**OTAY MESA CENTRAL VILLAGE  
SPECIFIC PLAN  
SAN DIEGO, CALIFORNIA**

Subject: 3rd UPDATE LETTER  
OTAY MESA CENTRAL VILLAGE SPECIFIC PLAN  
SAN DIEGO, CALIFORNIA

Subject: OTAY MESA CENTRAL VILLAGE SPECIFIC PLAN  
SAN DIEGO, CALIFORNIA

Subject: 2<sup>nd</sup> RESPONSE TO CITY OF SAN DIEGO REVIEW COMMENTS  
OTAY MESA CENTRAL VILLAGE SPECIFIC PLAN  
SAN DIEGO, CALIFORNIA

Otay Mesa Central Village Plan  
 Project No. 07254-42-04  
 Section A-A'  
 Name: A-A(2).gsz  
 Date: 1/12/2017

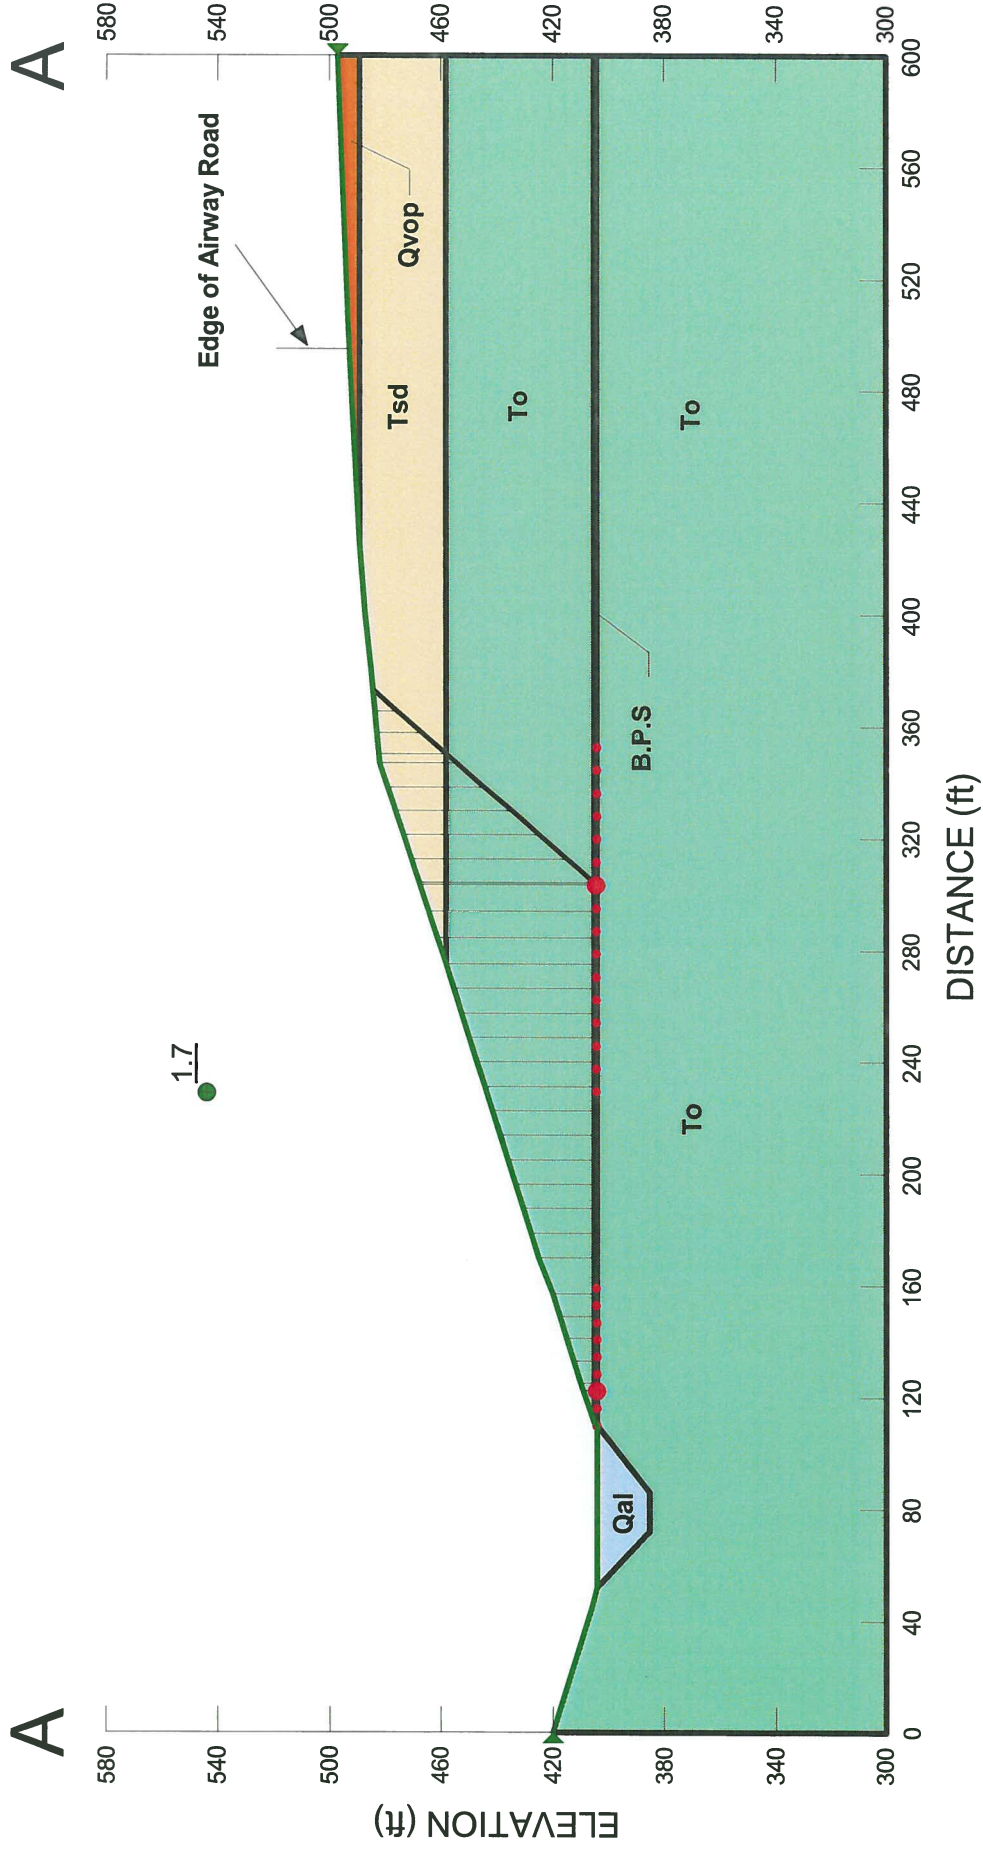
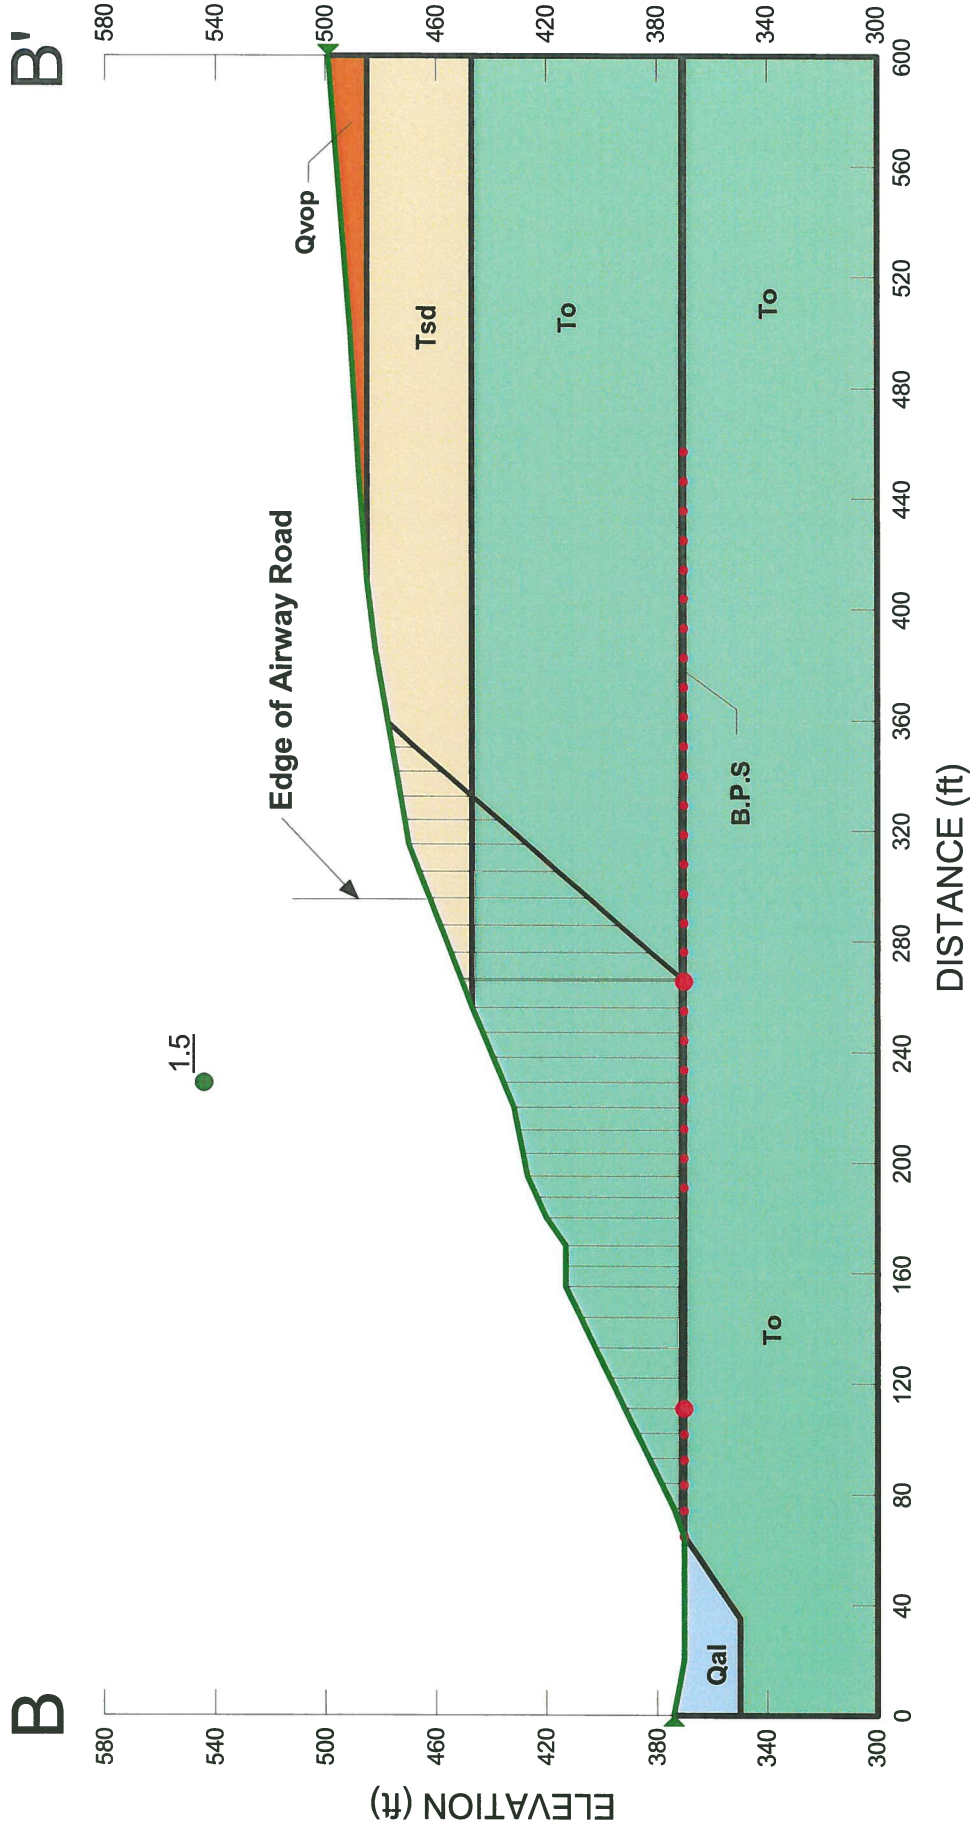
**Issue 19:** *If stabilization of the slope supporting the planned extension of Airway Road is necessary, identify the approximate limits of grading for the purpose of analyzing the impacts to environmentally sensitive lands.*

**Response:** We don't anticipate that stabilization of the slopes supporting the extension of Airway Road as shown on Reference 3 will be necessary. A slope stability analysis was performed assuming conservative geotechnical conditions along Cross Sections A-A' and B-B' (see Figure 1). The analysis considered the natural slope configuration and assumed the presence of a horizontal Bedding Parallel Shear (BPS) daylighting along the toe of the north-facing slope. Strength parameters for the bedrock and BPS materials were selected based on our experience with the geologic units in the area. The stability analysis was performed using Geoslope 2007. A graphic summary of the stability analysis is provided on Figures 2 and 3. The location of the stability cross sections are shown on Figure 1. Based on our analysis, the minimum factor of safety for the overall existing hillside at the two cross section locations is at least 1.5 or greater. The stability analysis should be confirmed once grading plans have been prepared and a geotechnical investigation has been performed.
